# ADDENDUM 1: SAMPLING AND ANALYSIS PLAN FOR THE PHASE 1 REMEDIAL INVESTIGATION FOR OPERABLE UNIT 2 GREAT KILLS PARK SITE, GATEWAY NATIONAL RECREATION AREA STATEN ISLAND, NEW YORK

Final

May 13, 2019

**Figure 1. Map Showing the Underwater Gamma Survey Results and Planned Sampling Activities**

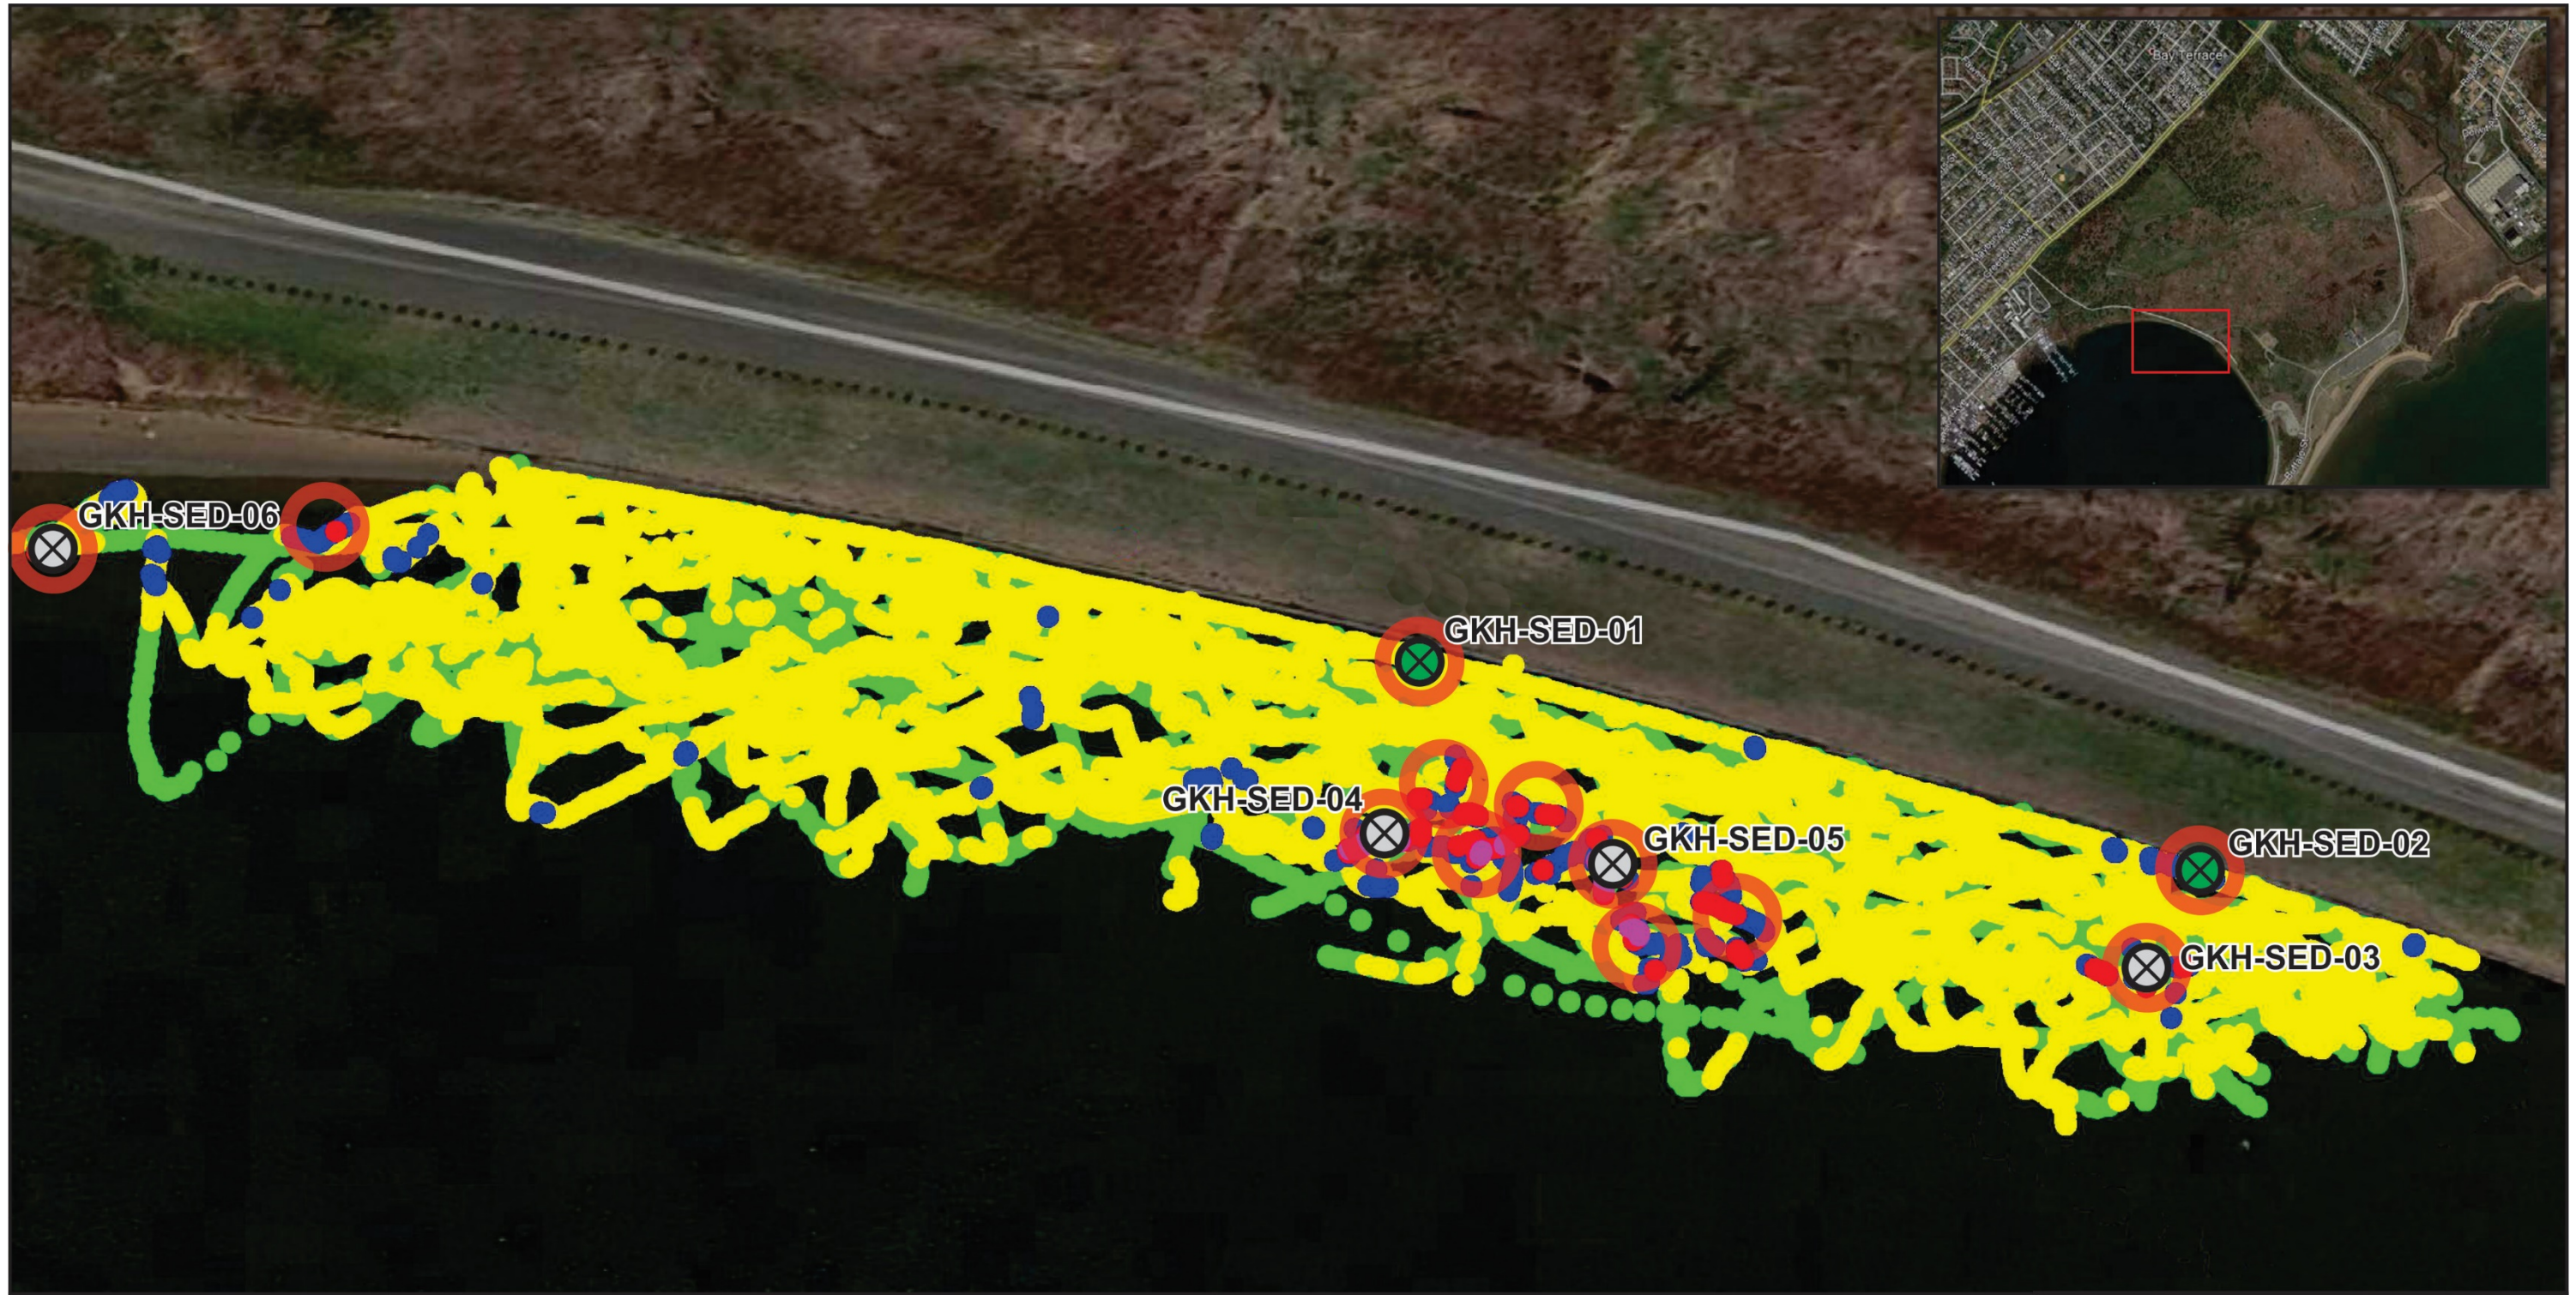
Sediment will be collected from six locations within the Great Kills Harbor, including two locations directly adjacent to the bulkhead. Each of the six sampling locations correspond to areas of the Great Kills Harbor in which radiological anomalies were identified during the underwater gamma radiation survey performed during Phase 1 sampling activities in 2018. **Figure 1** shows the planned sediment sampling locations and **Table 1** presents the coordinates.

For the two locations (see **Figure 1**) that can be accessed in shallow water from the bulkhead (i.e., GKH-SED-01 and GKH-SED-02), additional radiological surveys will be performed using a Canberra Osprey® multichannel analyzer (MCA). For these additional surveys, the MCA is coupled to a stabilized 2-inch by 2-inch NaI detector encased in a water tight PVC housing and connected to a field computer to operate the system. The MCA and field computer (i.e., with Canberra's proprietary software) allow the gamma radiation spectrum to be analyzed. Spectrums resulting from these additional radiological surveys will be reviewed by a Certified Health Physicist to evaluate the radionuclides that may be associated with the radiological anomalies identified during the underwater gamma radiation survey performed during Phase 1 investigation activities.
